UNITED STATES PATENT AND TRADEMARK OFFICE

APPLICATION NO.	FILING DATE	FIRST NAMED INVENTOR	ATTORNEY DOCKET NO.	CONFIRMATION NO.
10/655,854	09/05/2003	Rafael Reif	MIT-136AUS	7254
22494	7590	07/27/2005	EXAMINER	
DALY, CROWLEY, MOFFORD & DURKEE, LLP SUITE 301A 354A TURNPIKE STREET CANTON, MA 02021-2714			ANDUJAR, LEONARDO	
			ART UNIT	PAPER NUMBER
			2826

Office Action Summary	Application No.	Applicant(s)
	10/655,854	REIF ET AL.
	Examiner	Art Unit
	Leonardo Andújar	2826

DETAILED ACTION

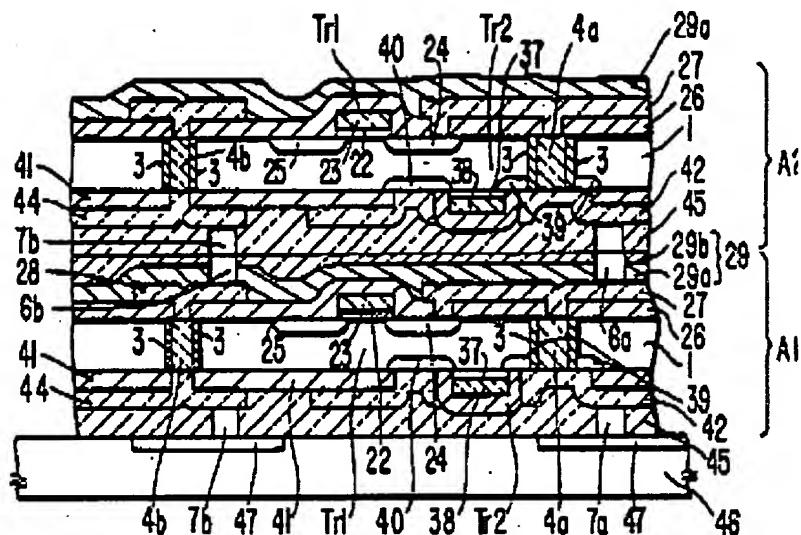
7. Regarding claim 1, Kato (e.g. fig. 3) show a multi layer integrated semiconductor structure, comprising:

- A first device layer including:
 - A first substrate 1 having provided therein a first plurality of doped regions (24, 25) which from at least part of one or more semiconductors elements (transistor);

- A dielectric material 29 disposed over the first substrate;
 - And a first conductive via 6a provided in the dielectric material, the first conductive via having a first end and a second end;

- A conductive interface 7b having a first surface disposed over at least a portion of the first device layer such that at least a portion of the conductive interface is couple to at least a portion of the first end of the first conductive via in the first device layer;

- A second device layer disposed over a second surface of the conductive interface, the second device layer including:
 - A second substrate 1 having provided therein a second plurality of doped regions (24, 25) which from at least part of one or more semiconductors elements (transistor);

- An insulating material (41, 45) having a surface disposed against a second surface of the conductive interface; wherein the second

device layer is secured to the first device layer via the interface; and a second conductive via 4a provided in the second device layer having a first end coupled to the conductive interface and having a second end coupled to at least one of the second plurality of doped regions such that an electrical path between the first device layer and the second device layer is provided by the first conductive via, the conductive interface and the second conductive via.

19. Regarding claim 17, Kato (e.g. fig. 3) show a multi layer integrated semiconductor structure, comprising:

➤ A first device layer 1 including:

- First and second opposing surface
- A first semiconductor region (24, 25);
- A first dielectric material 29 disposed about the first doped semiconductor region, the dielectric material having at least a first via hole 6a;
- A first conductive material 6a disposed in the via hole to provide a first conductive via having first and second opposing ends;

- A second device layer 1 having first and second opposing surfaces including:
 - At least a second doped semiconductor region (24, 25) and including a second via hole 4a; a second conductive material 4a disposed therein to provide a second conductive via having first and second ends;
- A first interface 7a disposed between a first one of the first and second opposing surfaces of the first device layer and a first one of the first and second opposing surfaces of the second device layer such that the first interface secures together the first and second device layers and also electrically couples the first device layer to the second device layer wherein the conductive interface and the first and second conductive vias forms at least a portion of an electrical communication path between the first device layer and the second device layer.
